UNITED STATES PATENT AND TRADEMARK OFFICE

APPLICATION NO.	FILING DATE	FIRST NAMED INVENTOR	ATTORNEY DOCKET NO.	CONFIRMATION NO.
09/998,069	11/30/2001	Scott Carleton Sanner	7784-000302/CPA	6261

Office Action Summary

DETAILED ACTION

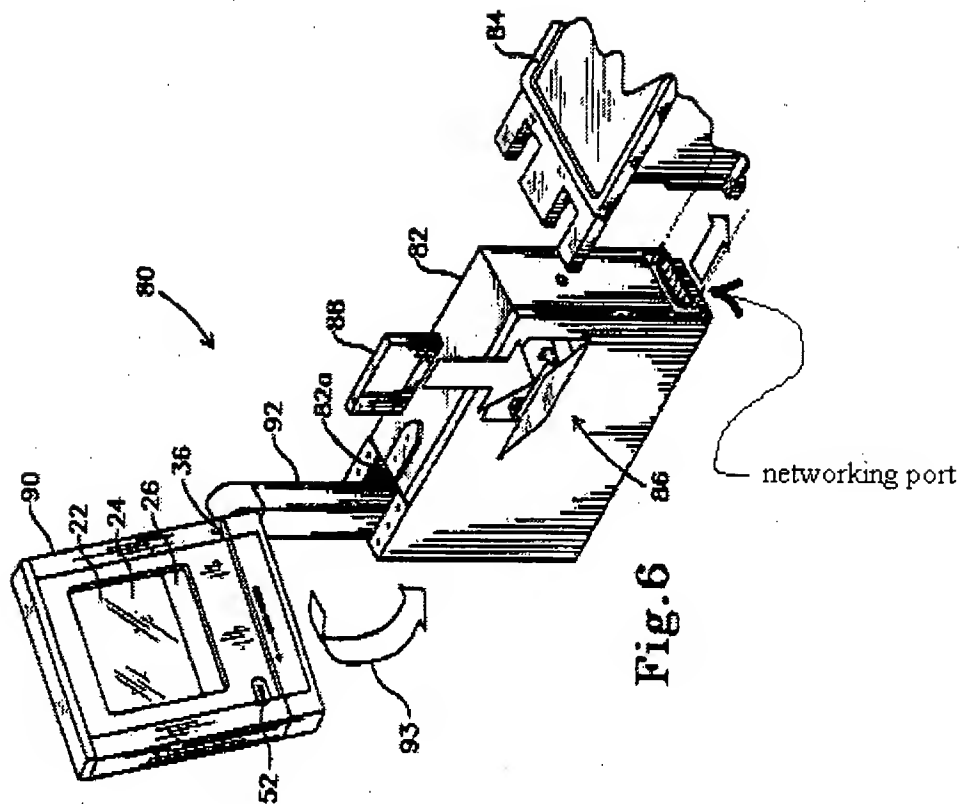
at least one networking port (see examiner's figure) disposed in the housing that can be adapted to couple the portable electronic device to the network for providing network connectivity of the portable electronic device;

the housing 82 having a manual pull feature for positioning the housing between one of a stowed position (within the armrest 84, see (cover sheet)) to a deployed position (as shown on the cover sheet) and a deployed position to a stowed position.
